**ROCK HARBOR COMMERCIAL WHARF IMPROVEMENTS
TOWNS OF ORLEANS, MA
ADDENDUM #3**

PROJECT: Rock Harbor Commercial Wharf Improvements

DATE: March 22, 2024

CONSULTING ENGINEER: Foth Infrastructure & Environment, LLC
15 Creek Road, Marion, MA 02738

PUMPOUT STATION SECTION
 SCALE: 1" = 1'

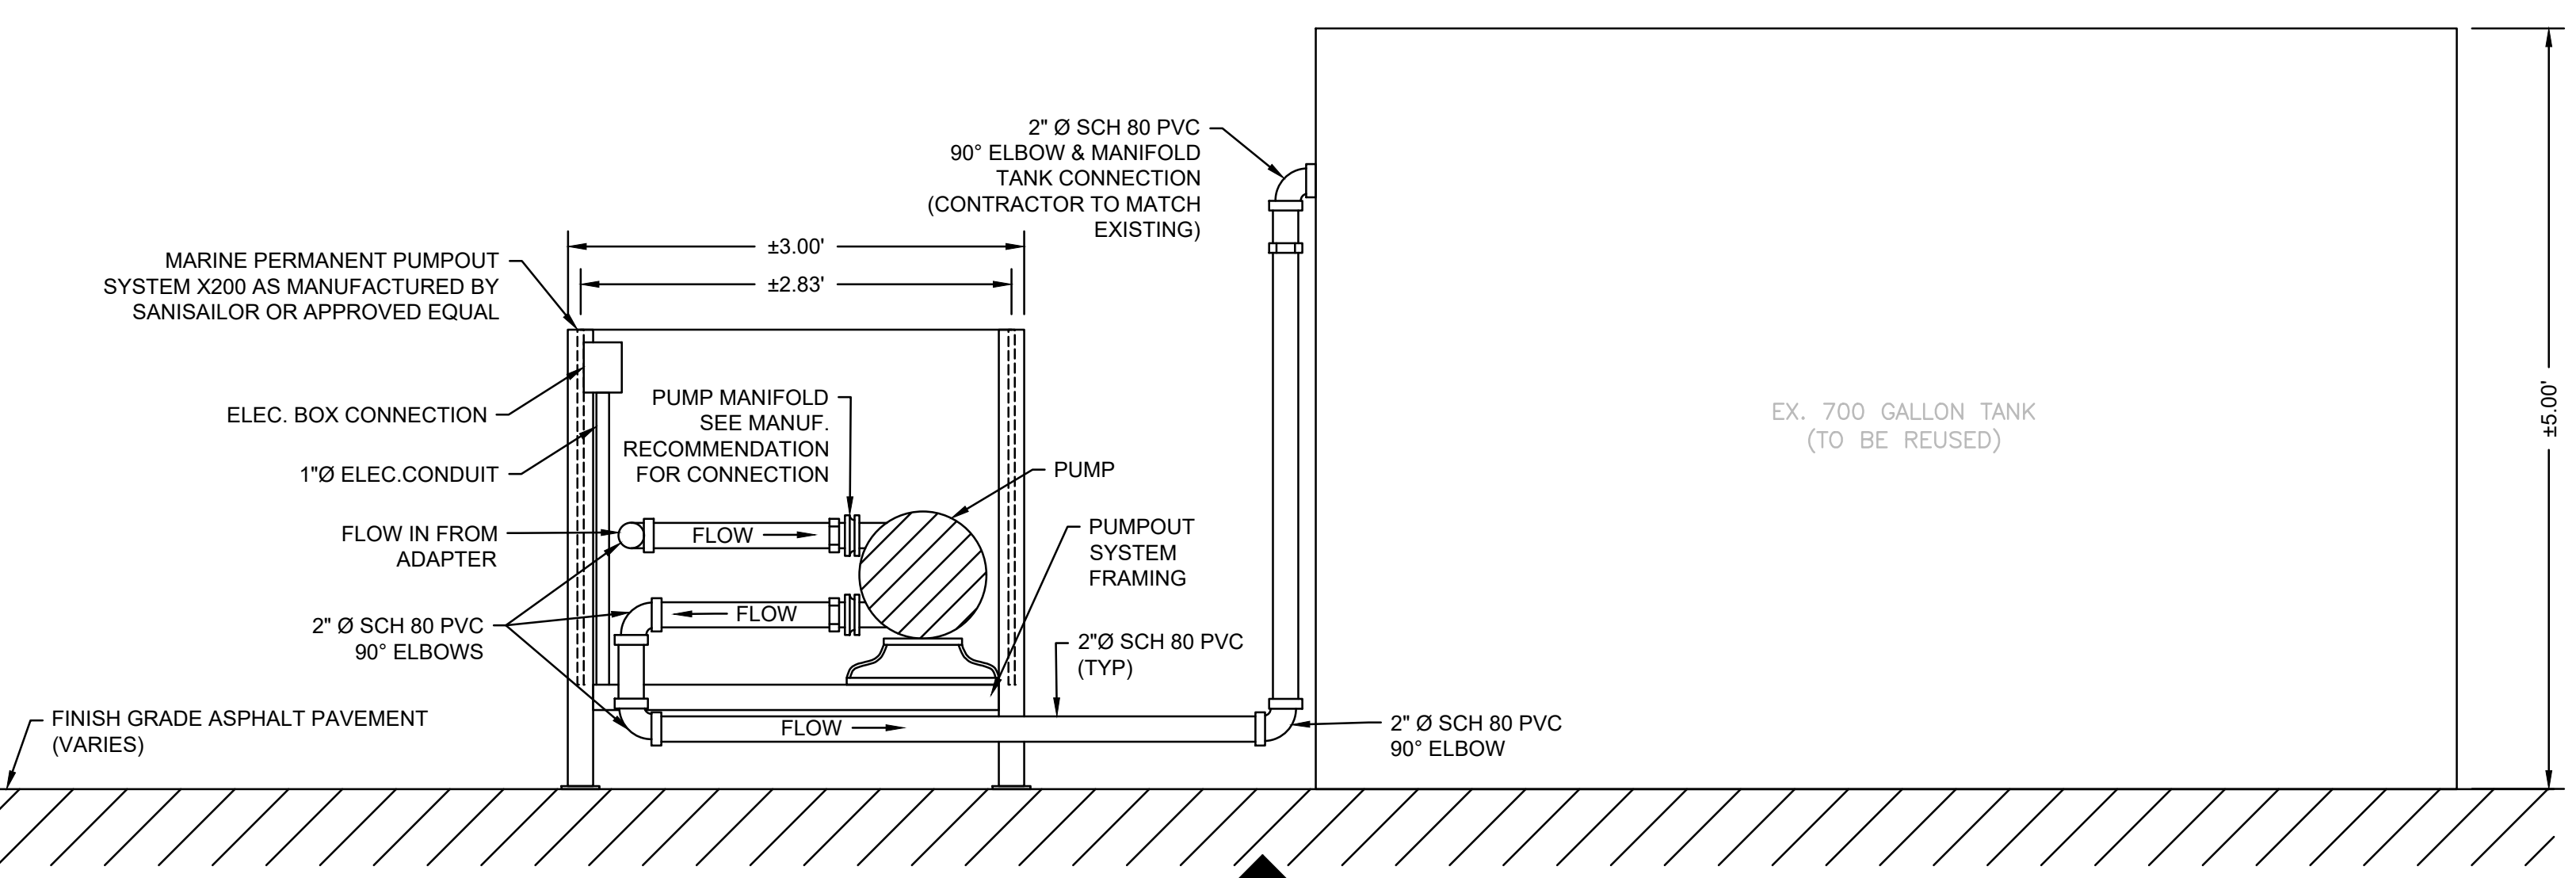
17. *Drawing C-202 shows some fence & gate at the relocated pump station location. Please advise whether this is a new timber fence. If so, please provide details of this timber fence & gate.*

RESPONSE: See sheet C-707 attached herein for new timber fence and gate detail.

SHEET TITLE:
**SECTION VIEWS
4 OF 4**

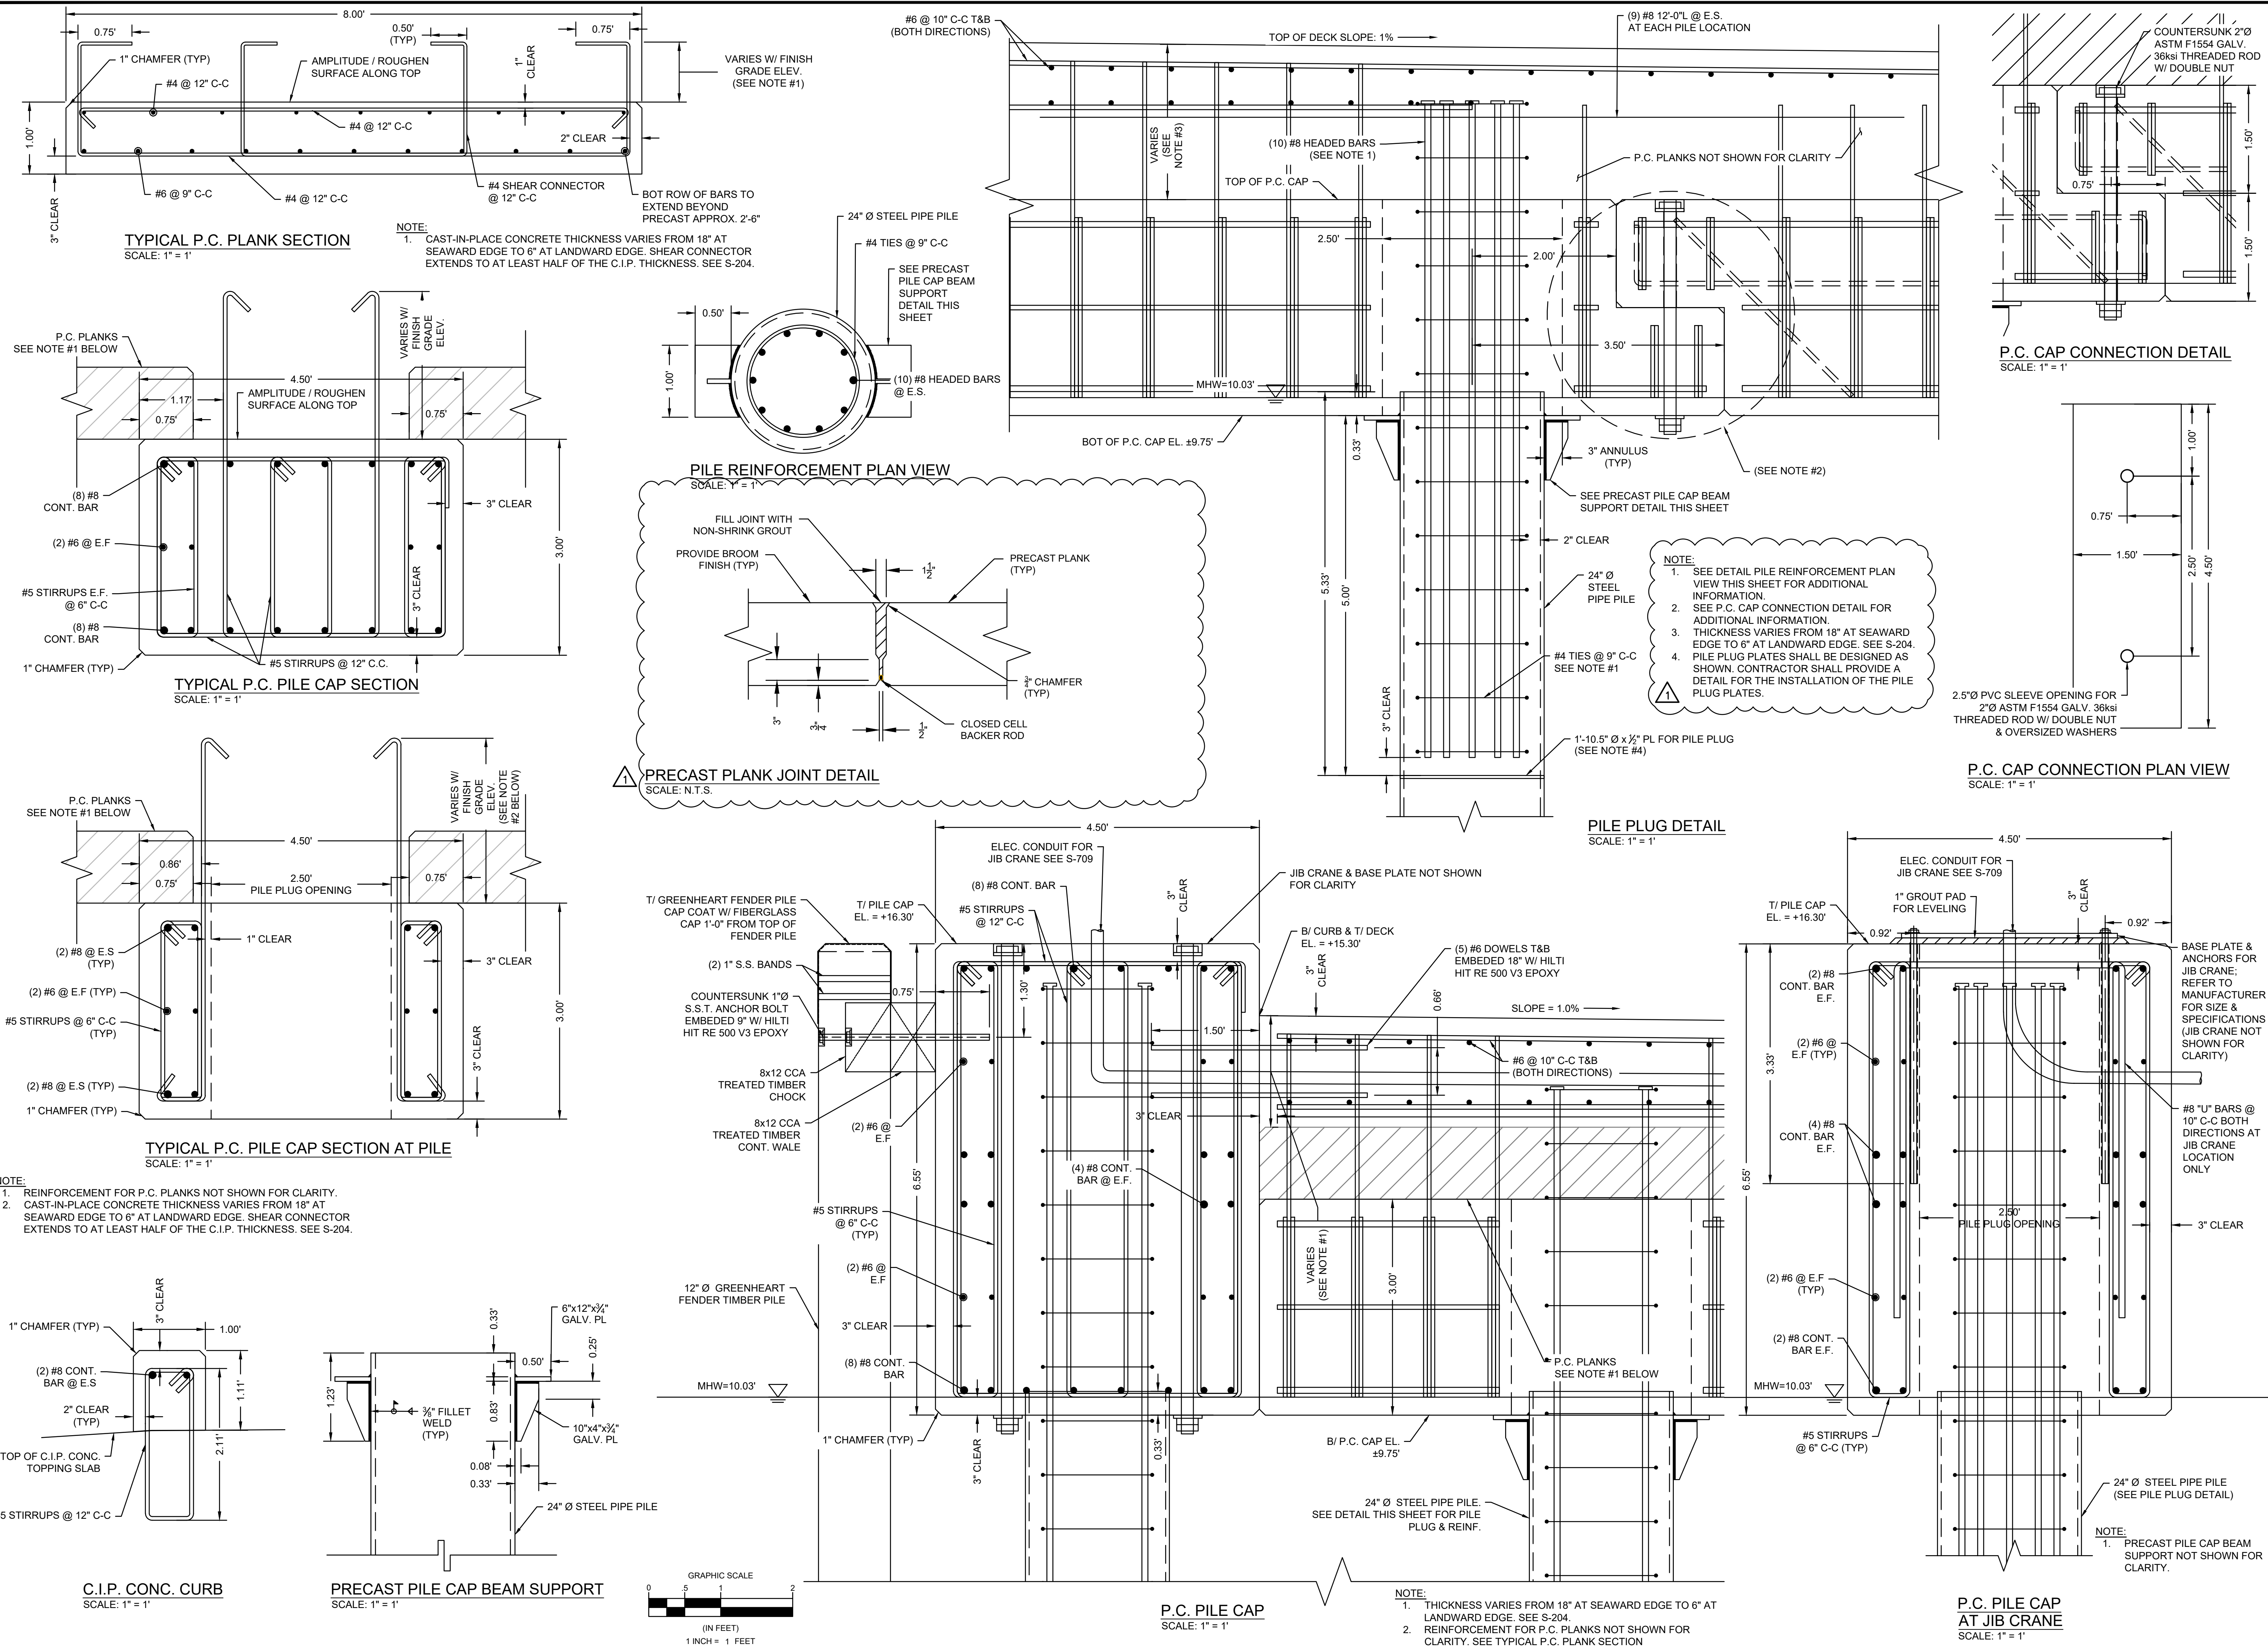
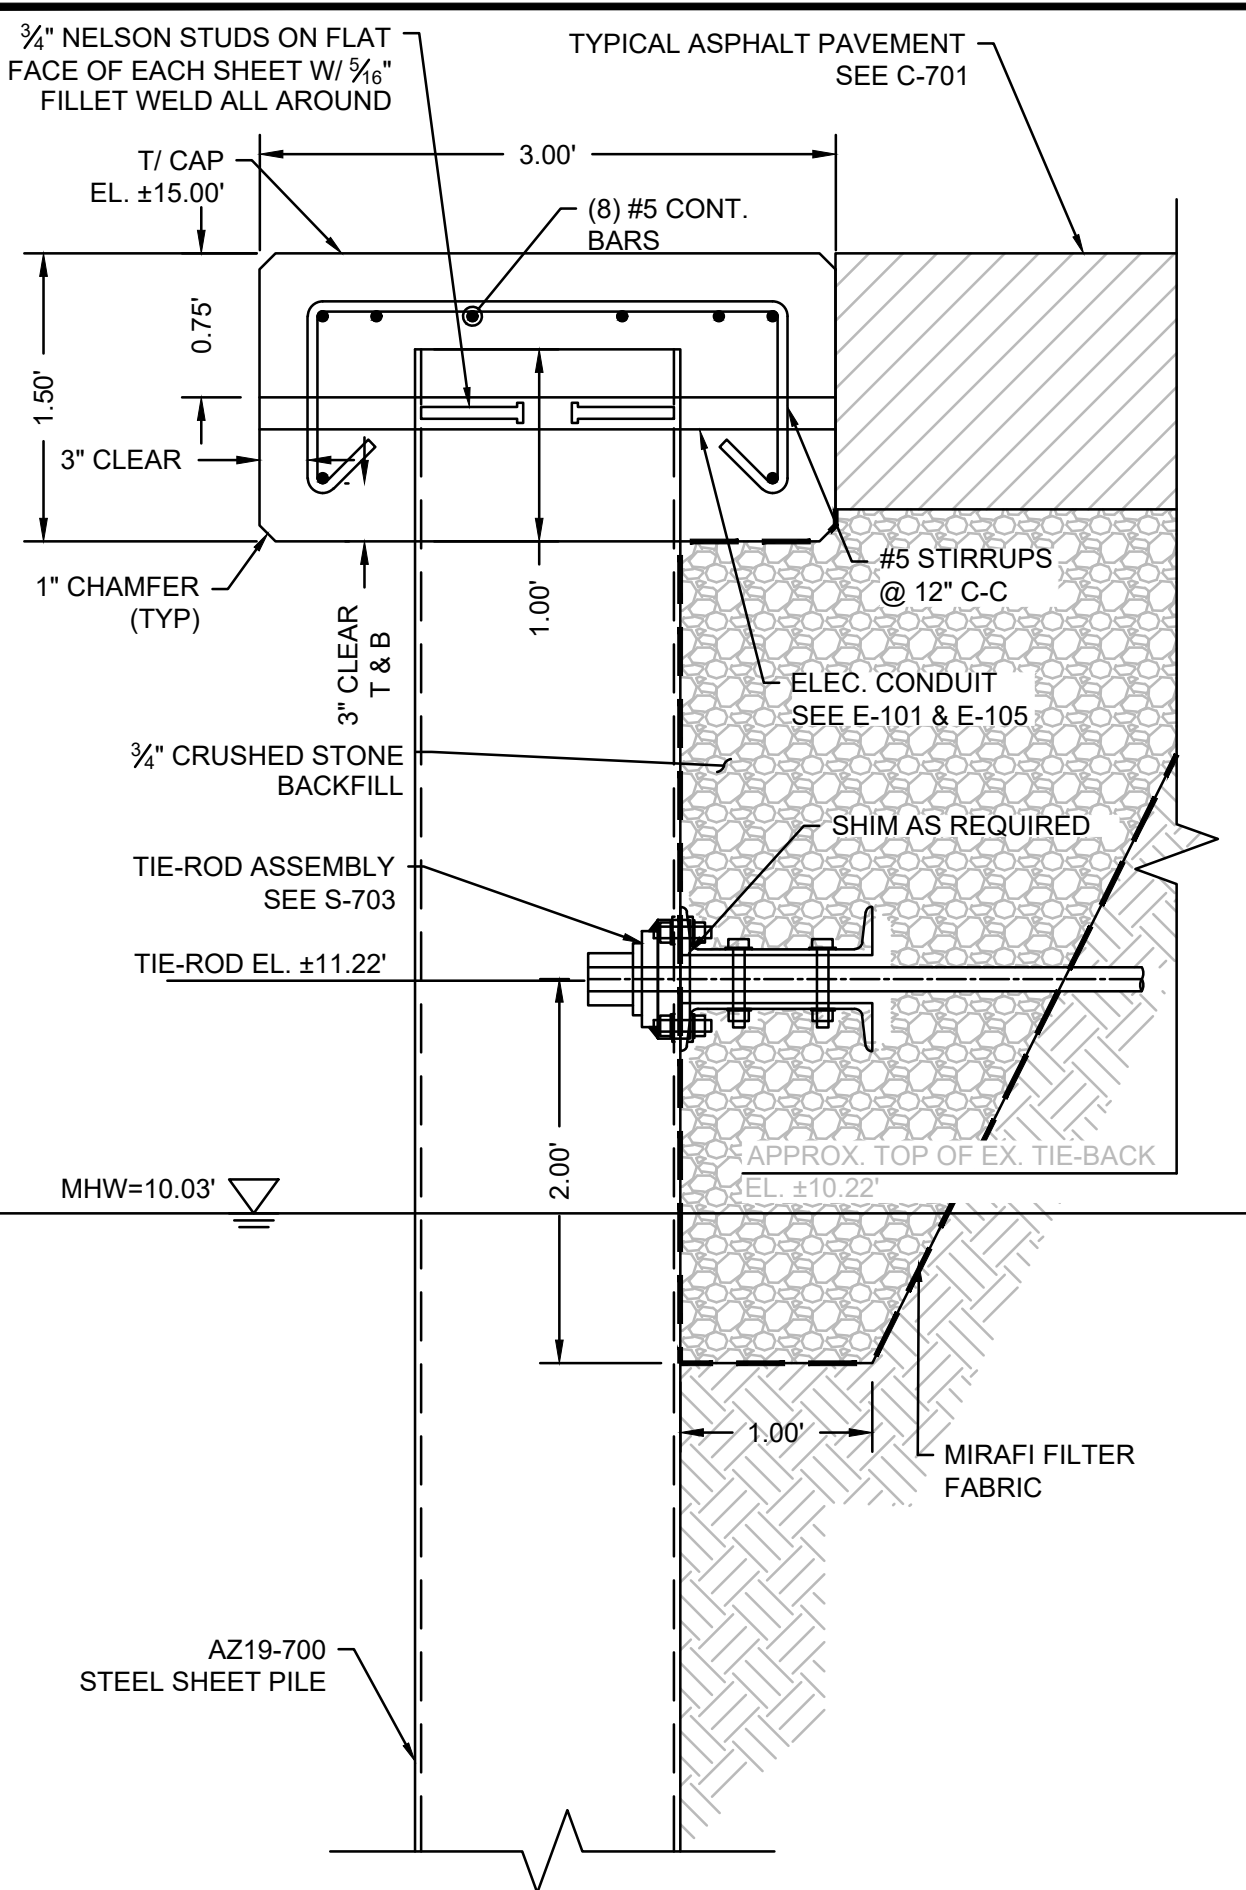
12. *Is there a grout joint or deck Panel shear key in between the precast deck planks? If so, please provide detail for the grout joint in between precast deck planks.*

53. Reference drawing S-504, "Pile Plug Detail", note 4. Are the pile plug plates that the Contractor is responsible for have a PE design intended to be structural plates or simply temporary form plates to support the weight of the concrete plug until it reaches design strength?

RESPONSE: See Precast Plank Joint Detail added to sheet S-504 attached herein.

RESPONSE: See sheet S-504 attached for revised note with reference to PE requirement removed. The plug plate shall be sized as shown on the drawing, but the installation means and methods will be the responsibility of the Contractor. The intent of the plug plate is a bottom form for temporary support of the concrete during installation of the pile plug.
